Submittal Review Response

Project Name: Hilo WWTP Rehabilitation and Replacement Project Phase 1
Submittal No.: 03200-003.0
Date: 9/25/2025

Client: County of Hawai'i **Carollo Project No.:** 203975
Contractor: Nan, Inc.
Submittal Name: Concrete Reinforcing Screening Wall and Top Slab
Reviewed By: Marissa Kurniawan, Hipom Caleb Che

TOP LONG WAY REINFORCEMENT DETAILS
SCREENING TOP SLAB REINFORCEMENT LAYOUT
SCALE - 1/4"=1'-0"
REF:02-S-01-104

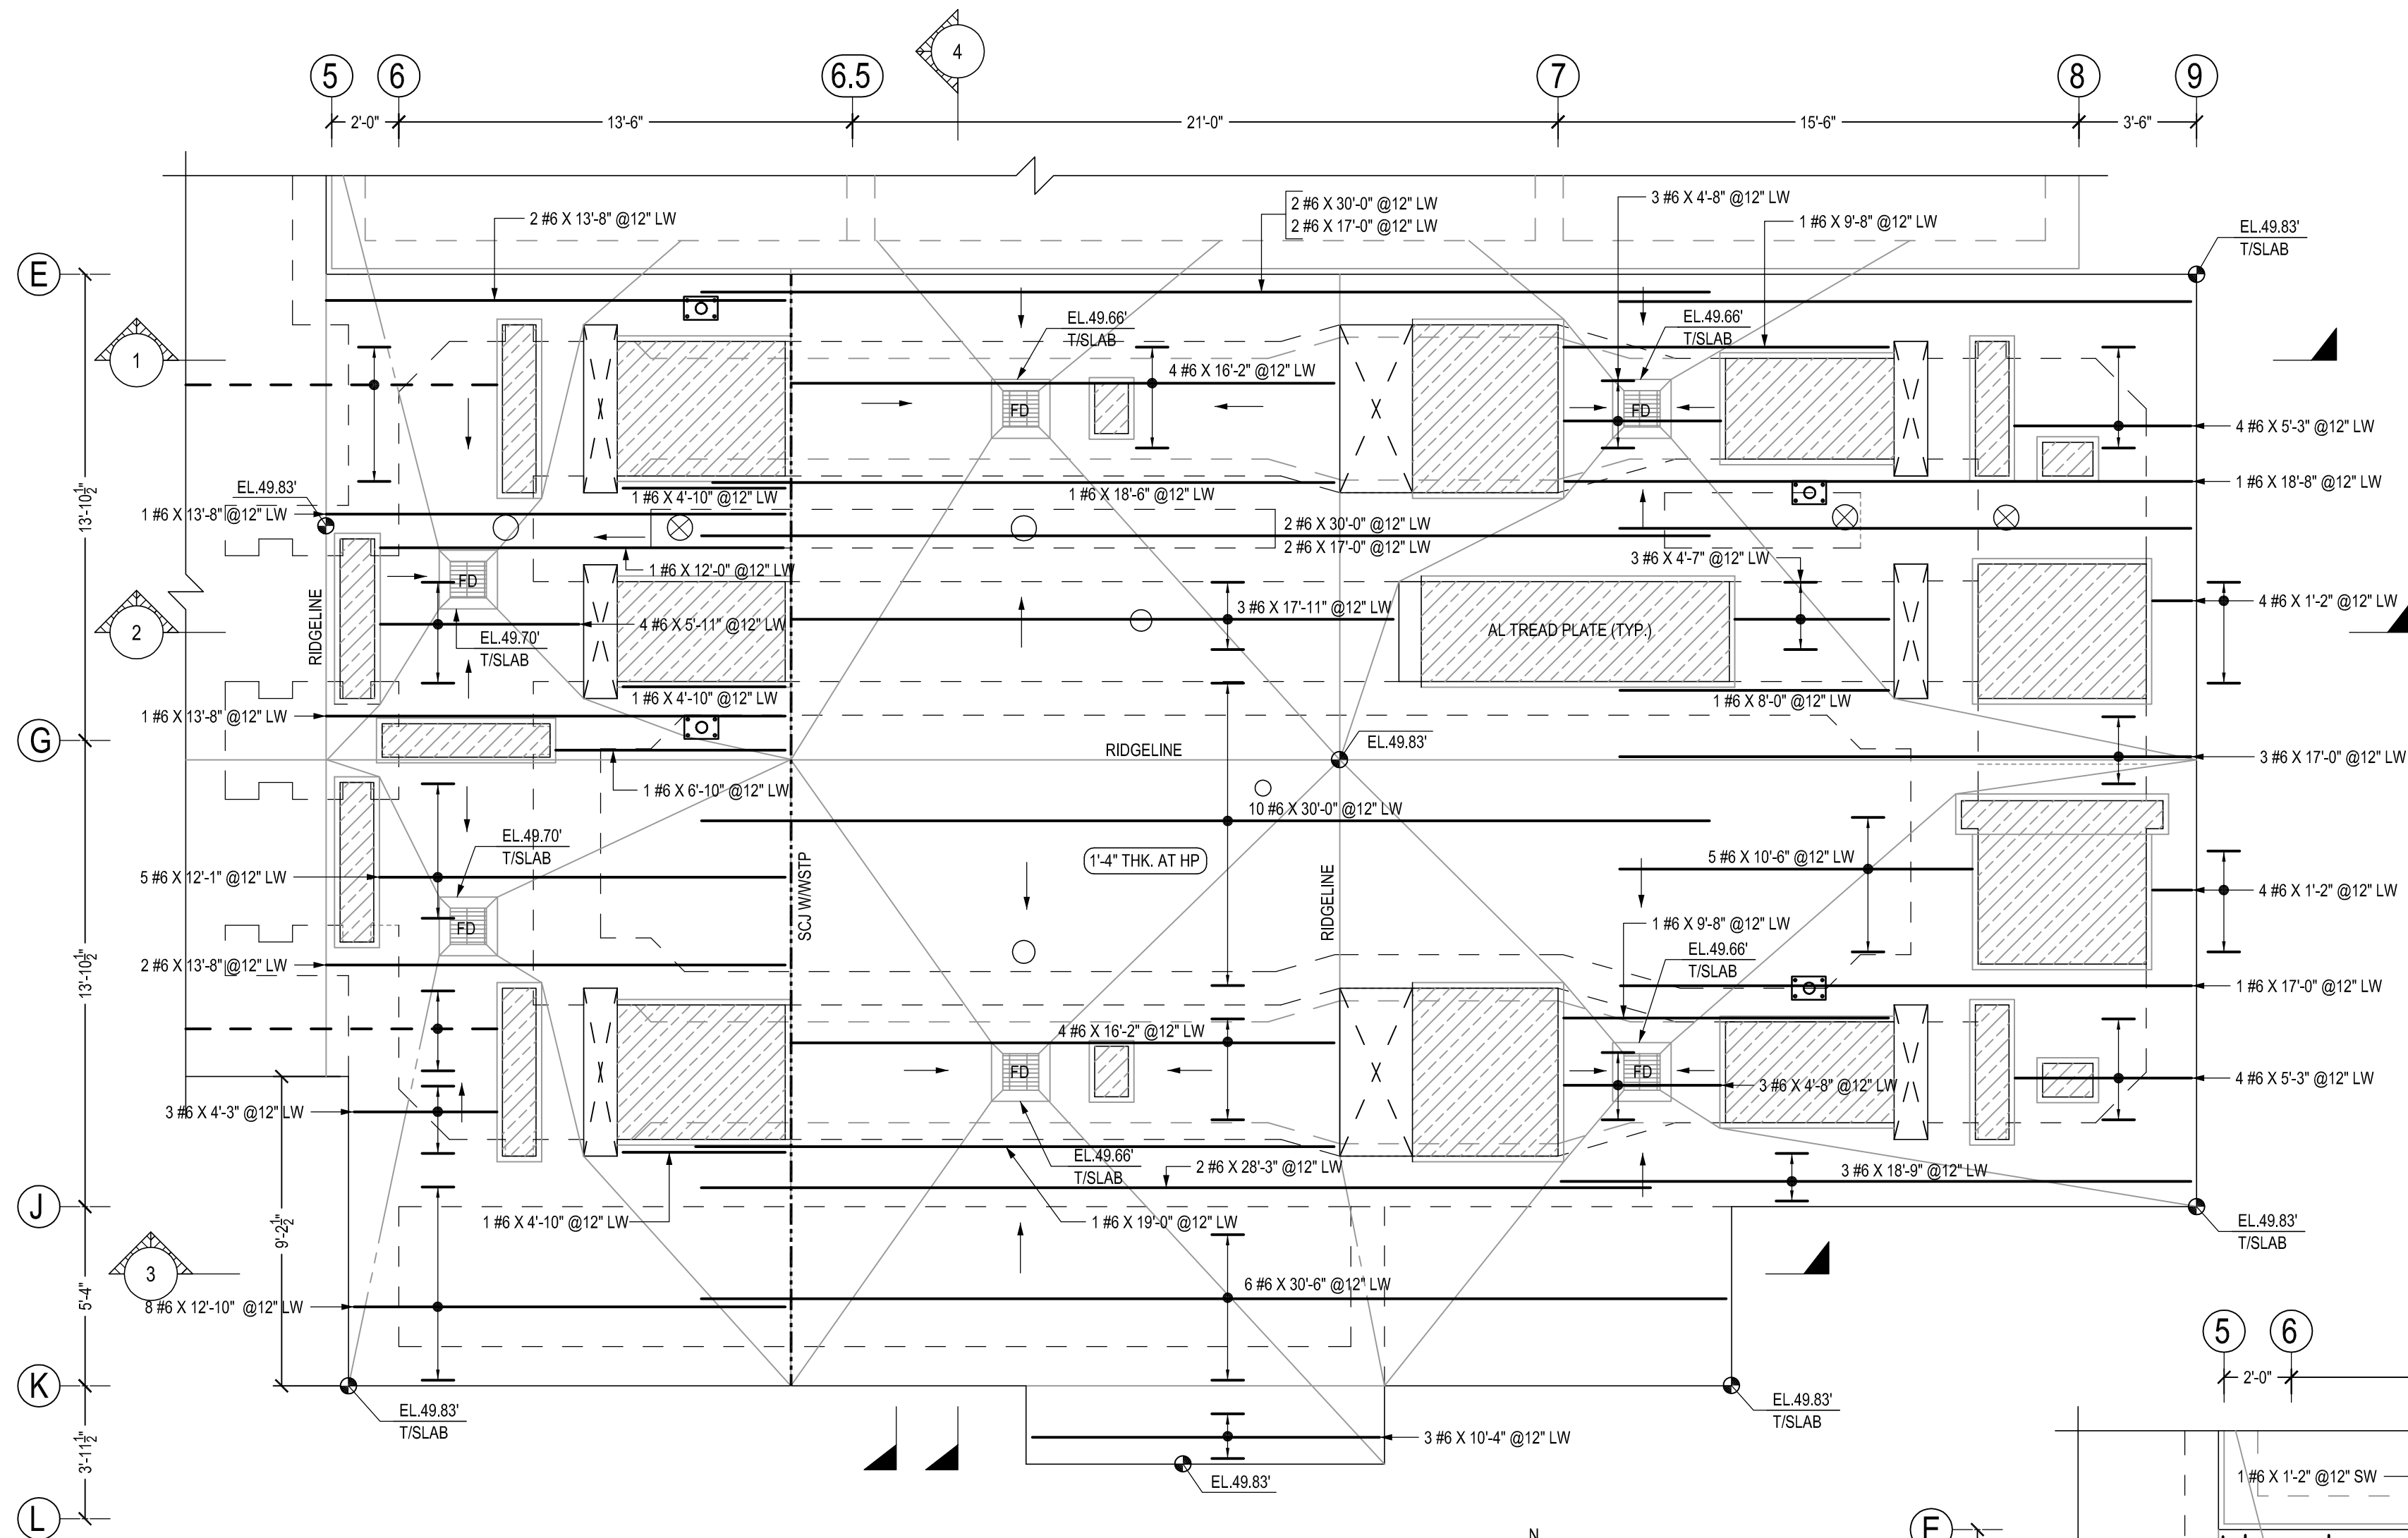
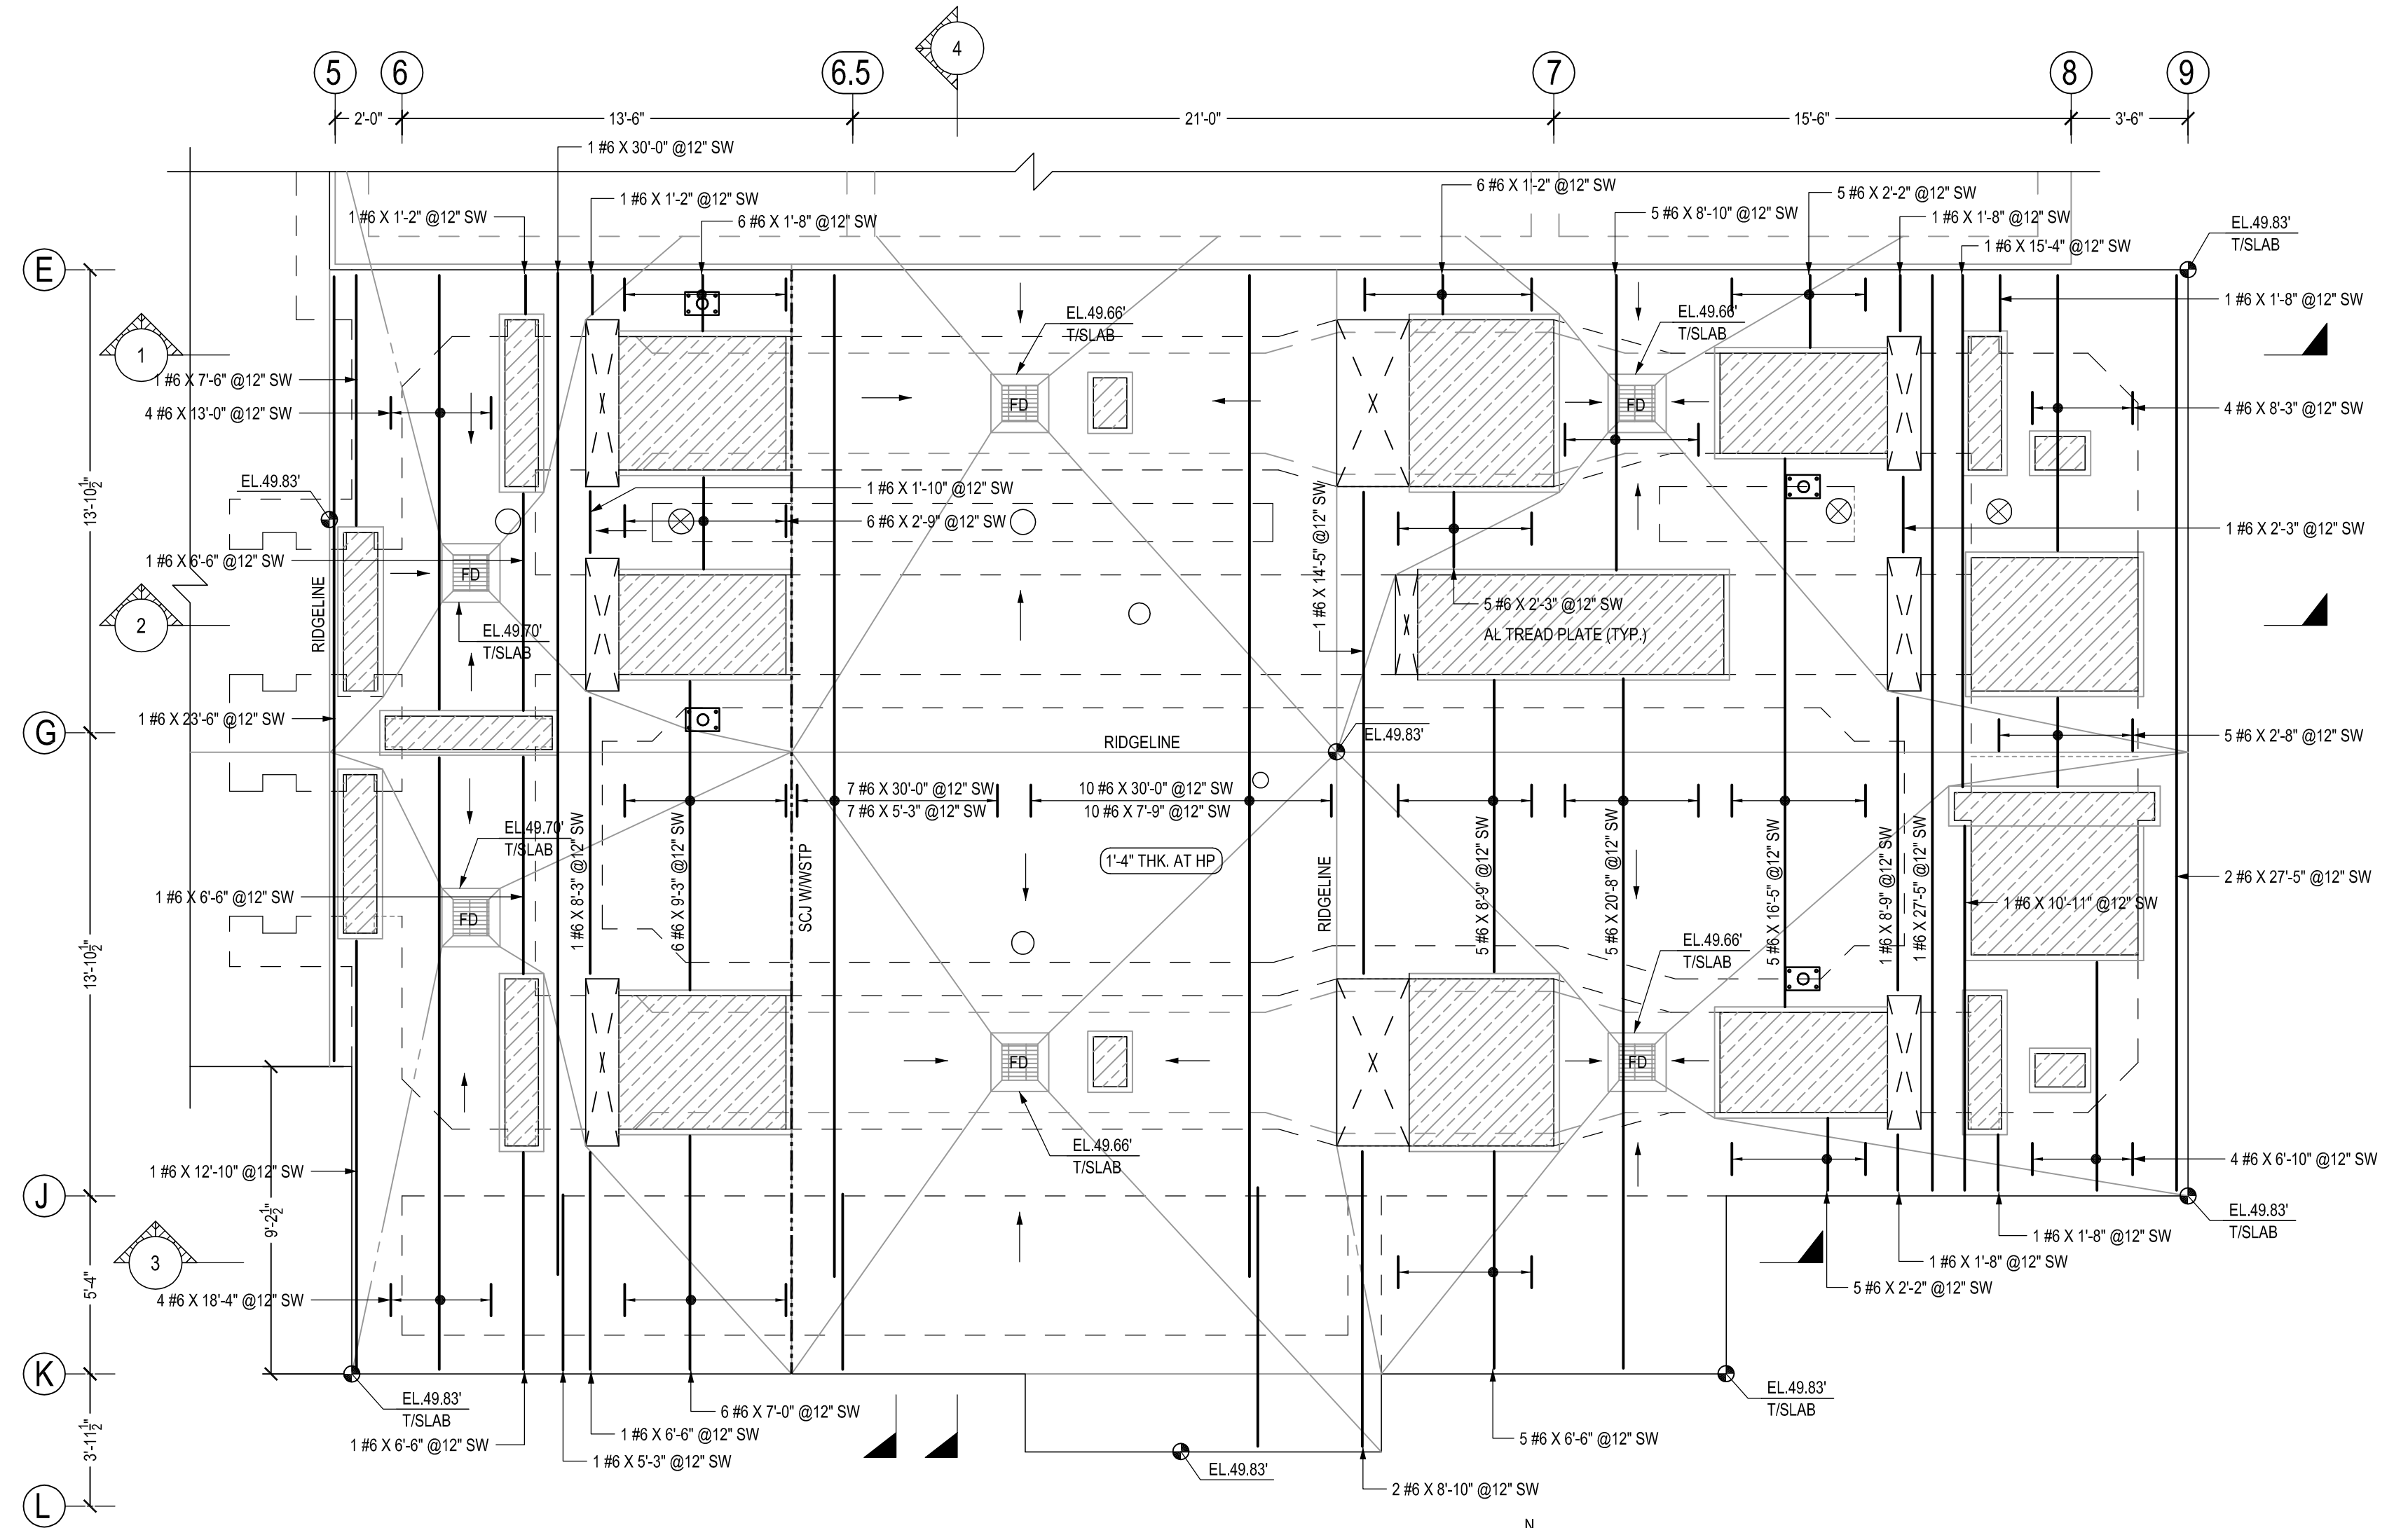
- The reinforcement detailing between slab openings on the screening top slab plan view is unclear (clouded areas on submittal page 3 and 4). Revise to clearly show 3 #6 bars top & bottom total for each clouded area on plan shop drawings per contract drawing 02-S-01-104, keynote 9 and detail 10/02-S-01-501.

- Screening top slab reinforcement plan view drawings show horizontal reinforcement spanning long way and short way going through small openings. Verify and coordinate reinforcement arrangement in areas with these openings and revise shop drawings as necessary.

- Contractor shall coordinate the final opening dimensions with the bar screen equipment dimensions. Reinforcement dimensions in corresponding areas shall be revised accordingly with the final opening dimensions.
